UNITED STATES ENVIRONMENTAL PROTECTION AGENCY
REGION IX

SUBJECT: Technical Review of the Naval Station Treasure Island
Hunters Point Annex Treatability Study Work Plan

SUBJECT: Technical Assistance: Review of Soil Flushing for Hunters Point,
San Francisco, CA

Subject: ARCSWEST Program Contract No. 68-W9-0060
Hunters Point Annex Work Assignment No. 60-05-9PP3
Review of the Navy's Draft Treatability Study Work Plan Operable Unit I, Site IR-3
and the Navy's Draft Treatability Study Work Plan for Treating Subsurface
Petroleum Products at Site IR-3 by Biodegradation

2-3

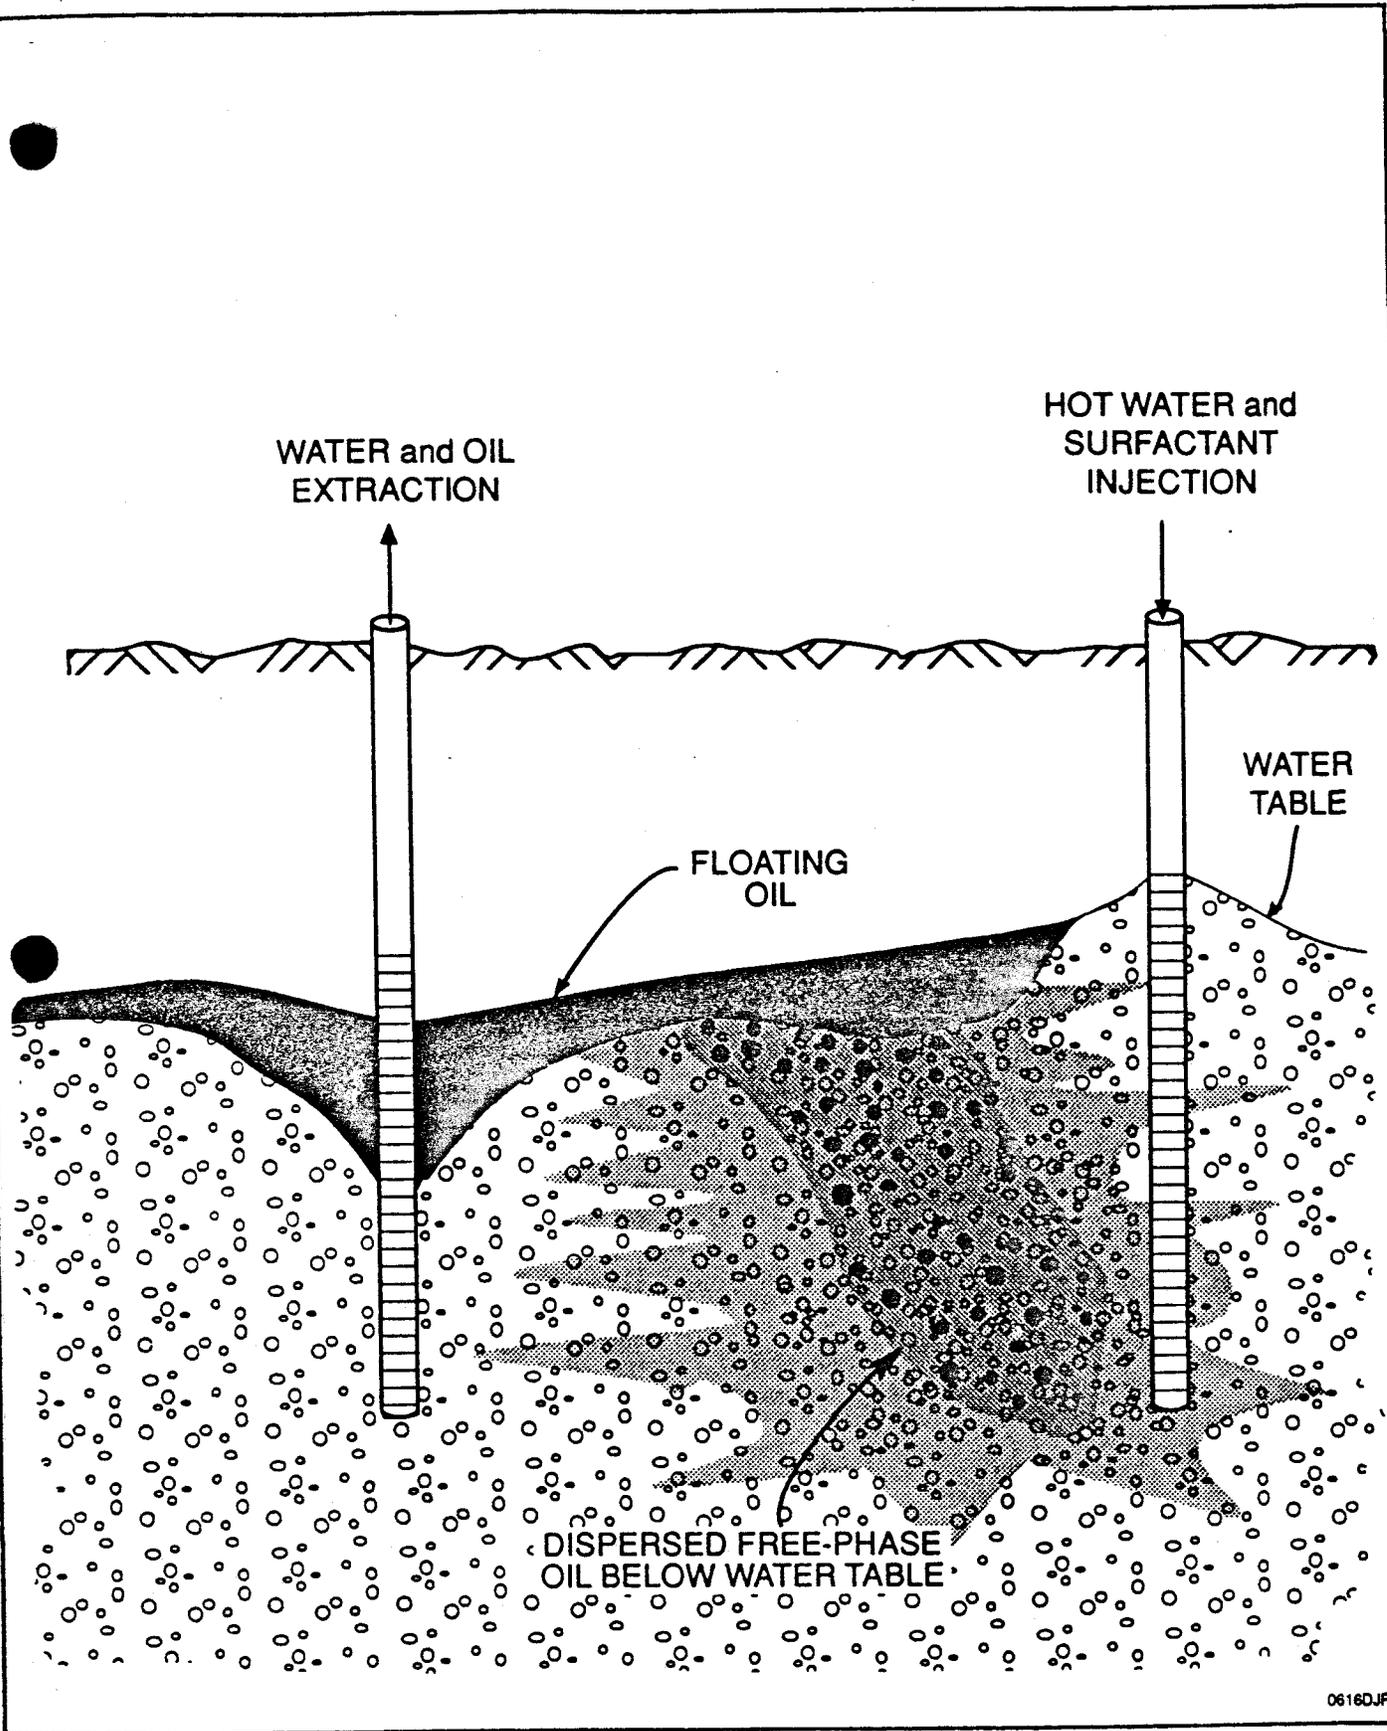
It is not clear, whether the described technology in section 2.0 of the work plan is actually soil flushing (Bechtel refers to it as in-situ soil washing - see attachment 1) or just ground water extraction with re-injection of heated water containing surfactants. Attachment 2 (plate 2-3) is the schematic from the work plan. Attachments 3 and 4 (see EPA/540/2-91/021 "Engr. Bulletin-In Situ Soil Flushing and EPA/540/2-90/002 "Handbook on In Situ Treatment of Hazardous Waste-Contaminated Soils") are typical schematics for soil flushing systems. Apparently, there is some confusion which needs to be clarified. Is the proposed remedial technology similar to "Pump and Treat" or is it a mis-representation of soil flushing? Consequently, it is imperative that this issue be resolved before any testing is conducted.

4. The conceptual model of oil contamination and proposed treatment as presented in Section 2.1 and Plates 1-2, 1-3, 2-1, and 2-3 oversimplifies this site. The effect of tidally influenced groundwater level fluctuations, the salinity of the groundwater, and the presence of debris zones should be explicitly addressed and considered in the design of this treatability study.
